Amendment to Design and Access Statement accompanying Planning Application 2013/4970/P

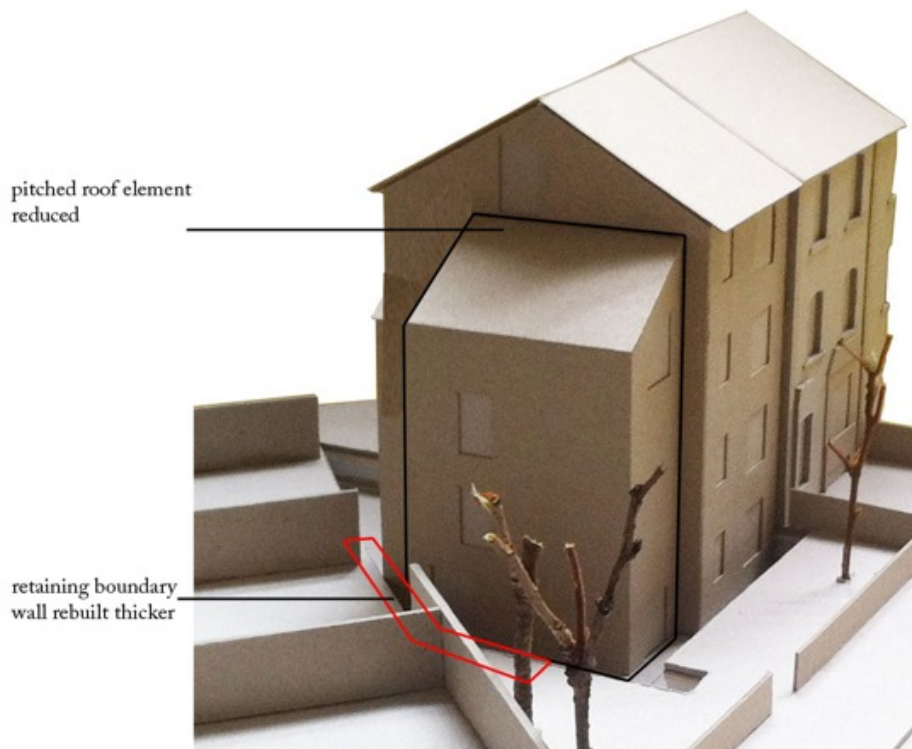
- Because we have less space to the side we have decided the best solution is for the extension to follow the line of the site boundary which means extending the proposed backwards, and chamfering or angling the plan reflecting the site boundary.
- Whilst retaining the pitched roof element over the main body of the extension We have proposed a flat roof at the chamfered, angled rear section rather

than continue the pitched roof with an unattractive and fiddly hipped gable roof.

- We have additionally proposed a slight increase in width of 350mm to the extension as the proposed bedrooms were becoming too narrow after the insulation build up.

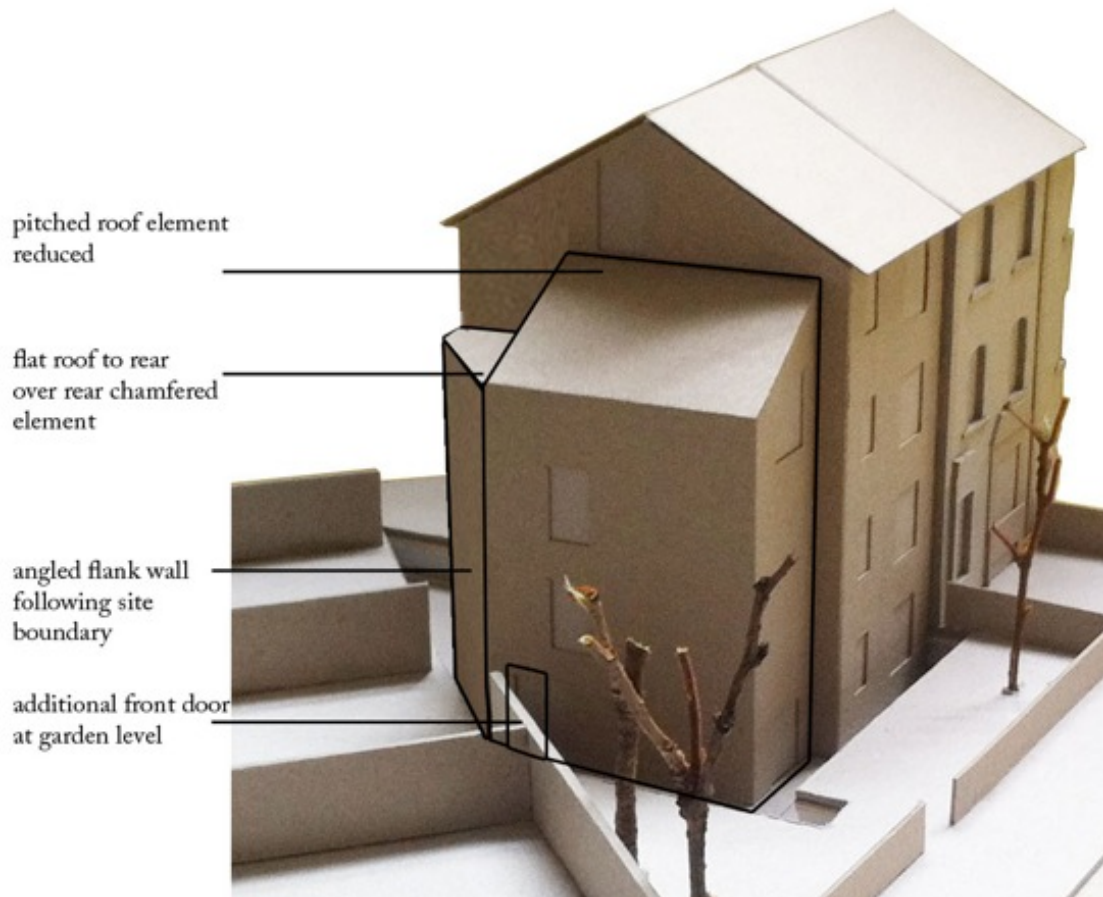
- In order to comply with building regulations we have introduced a new front door for the 1st, 2nd and 3rd floor flats at the garden level into the north elevation. This is approximately at the level of the entrance to the 1st floor flat's extension. And thus saves the inhabitants going down a full storey to go back up again and helps us comply with building regulations. The door is accessed by a walkway over the side alley.

- We propose a new railing to prevent falling from the garden level to proposed new basement level
- We propose keeping a secondary front door beneath the walkway for communal access to the rear courtyard and for the inhabitant of the lower ground floor flat (flat 1), this area also allows some storage for push chairs etc by the inhabitants of all the units. This variation is largely unseen externally as it is below ground. Please see diagrams for explanation.
